# Access Compliance Report

## Public Rights-of-Way (Curb Ramps)

Intersection ID: 49399	Main Street: CHILFORD_CT	Cross Street: HEREFORD_ST	Location:	N
ADA ID: AF63175BDCBC	Ramp Type: BlendTrans1	Initial Pass/Fail: Fail	Overall Compliance: No	Severity Score: 8.75
Codes/Mitigation Info/Possible Solution		Field Measurements/Component Compliance

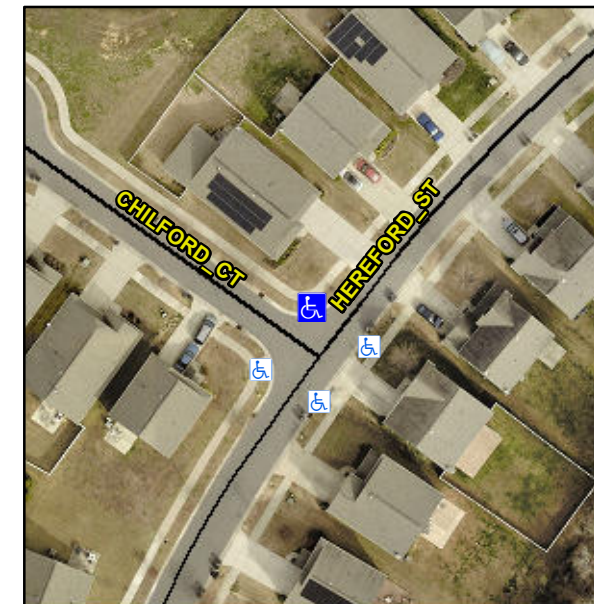
**Not Found, R304.5.1**

Compliance	Description	Data	Compliance	Description	Data
N/A	Ramp Length (in)	71.5	Yes	BlendTrans Slope (%)	2.9
No	Ramp Width (in)	46.0	Yes	BlendTrans XSlope (%)	0.6
N/A	Flare Type LT	N/A	N/A	Flare Type RT	N/A
N/A	Flare Slope LT (%)	N/A	N/A	Flare Slope RT (%)	N/A
N/A	Flare Traversable LT?	N/A	N/A	Flare Traversable RT?	N/A
N/A	Landing Length (in)	N/A	N/A	DWS Provided?	N/A
N/A	Landing Width (in)	N/A	N/A	DWS Contrast?	N/A
N/A	Landing Slope (%)	N/A	N/A	DWS Length (in)	N/A
N/A	Landing X Slope (%)	N/A	N/A	DWS Full Width?	N/A
N/A	Landing Curb? (Y/N)	N/A	N/A	DWS Offset (in)	N/A
N/A	Shared Landing?	N/A			
N/A	Gutter Ponding?	N/A	N/A	Gutter Slope (%)	N/A
N/A	Gutter Lip Ht (in)	N/A	N/A	Gutter X Slope (%)	N/A
N/A	Painted X Walk1?	No	N/A	Painted X Walk2?	No
	X Walk 1 Direction	To SW		X Walk 2 Direction	To SE
	X Walk 1 Width (in)	N/A		X Walk 2 Width (in)	N/A
	X Walk 1 Slope (%)	2.2		X Walk 2 Slope (%)	2.3
	X Walk 1 X Slope (%)	1.6		X Walk 2 X Slope (%)	2.3

N/A	Ramp inside XWalk1?	N/A	N/A	Ramp inside XWalk2?	N/A
	Road Slope (%)	0.6		Clear Space?	N/A
	Road X Slope (%)	3.7	N/A	Clear Space to XWalk (in)	N/A
N/A	Any Obstructions?	N/A	N/A	Storm Grate/Utility Hazard?	N/A
	Obstruction Type			Storm Grate/Utility Type	
		N/A			N/A
			Yes	Surface Condition? (G/P)	Good
			No	Curb Slope (%)	15.6

**Remove & Replace Curb Ramp With Two New Directional Ramps or Equivalent.**
